Well Name: BIG EDDY UNIT 30E SKYWALKER	Well Location: T20S / R31E / SEC 14 / NWSW / 32.570285 / -103.8471	County or Parish/State: EDDY / NM
Well Number: 102H	Type of Well: OIL WELL	Allottee or Tribe Name:
Lease Number: NMLC0063667, NMLC063667	Unit or CA Name: BIG EDDY	Unit or CA Number: NMNM68294X
US Well Number: 3001546933	Well Status: Approved Application for Permit to Drill	Operator: XTO PERMIAN OPERATING LLC

Sundry ID: 2713482

Type of Submission: Notice of Intent	Type of Action: APD Change
Date Sundry Submitted: 02/01/2023	Time Sundry Submitted: 08:52
Date proposed operation will begin: 02/06/2023

Procedure Description: **Casing & Cement Changes XTO Permian Operating, LLC requests permission to make the following changes to the original APD: Casing and cement changes due to US supply chain issues. Updated drilling program is attached. Attachments: Drilling Program MBS Diagram

20" x 9-5/8" x 7-5/8" x 5-1/2" MBU-T-CFL-R-DBLO Wellhead
With 11" 10M x 7-1/16" 15M CTH-DBLHPS Tubing Head
And 9-5/8", 7-5/8" & 5-1/2" Pin Bottom Mandrel Casing Hangers

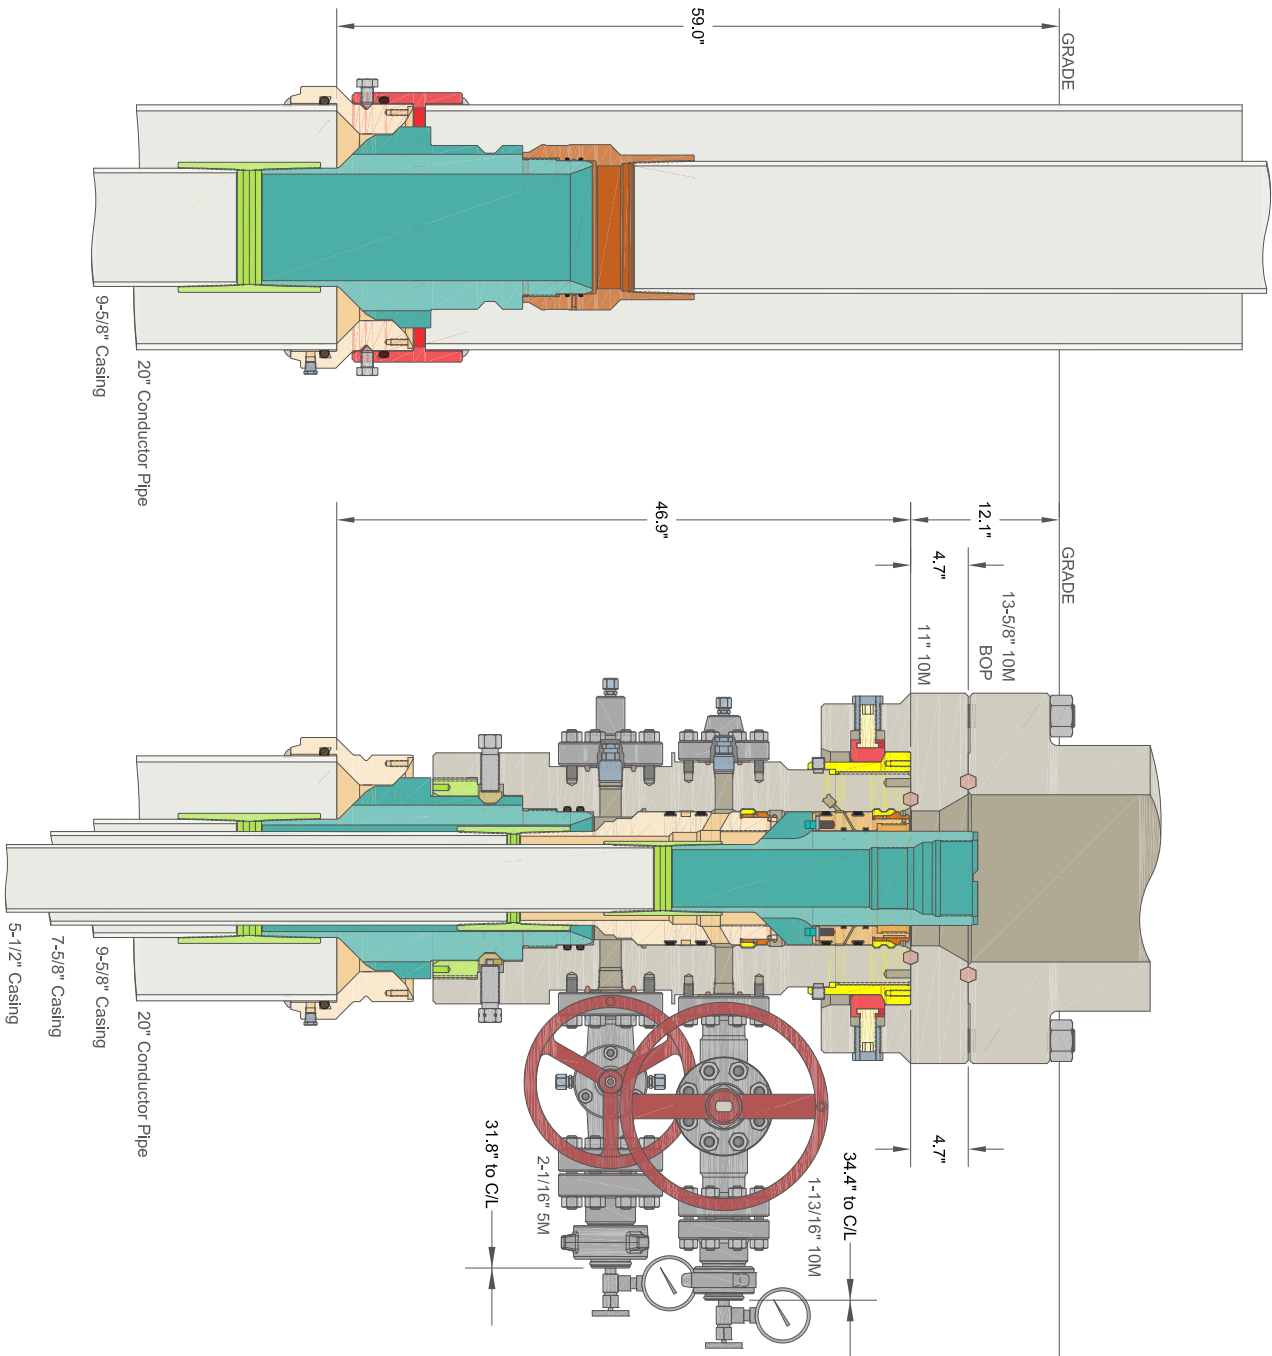
Permanent Wellhead – Multibowl System

A. Starting Head: 13-5/8" 10M top flange x 13-3/8" bottom

B. Tubing Head: 13-5/8" 10M bottom flange x 7-1/16" 15M top flange

- Wellhead will be installed by manufacturer's representatives.
- Manufacturer will monitor welding process to ensure appropriate temperature of seal.
- Operator will test the 9-5/8" casing per BLM Onshore Order 2
- Wellhead Manufacturer representative will not be present for BOP test plug installation

1. Variance approved to use flex line from BOP to choke manifold. Manufacturer's specification to be readily available. No external damage to flex line. Flex line to be installed as straight as possible (no hard bends).'
2. Operator has proposed a multi-bowl wellhead assembly. This assembly will only be tested when installed on the surface casing. Minimum working pressure of the blowout preventer (BOP) and related equipment (BOPE) required for drilling below the surface casing shoe shall be **2000 (2M) psi**.
 - a. Wellhead shall be installed by manufacturer's representatives, submit documentation with subsequent sundry.

- b. If the welding is performed by a third party, the manufacturer's representative shall monitor the temperature to verify that it does not exceed the maximum temperature of the seal.
- c. Manufacturer representative shall install the test plug for the initial BOP test.
- d. If the cement does not circulate and one inch operations would have been possible with a standard wellhead, the well head shall be cut off, cementing operations performed and another wellhead installed.
- e. Whenever any seal subject to test pressure is broken, all the tests in OOGO2.III.A.2.i must be followed.
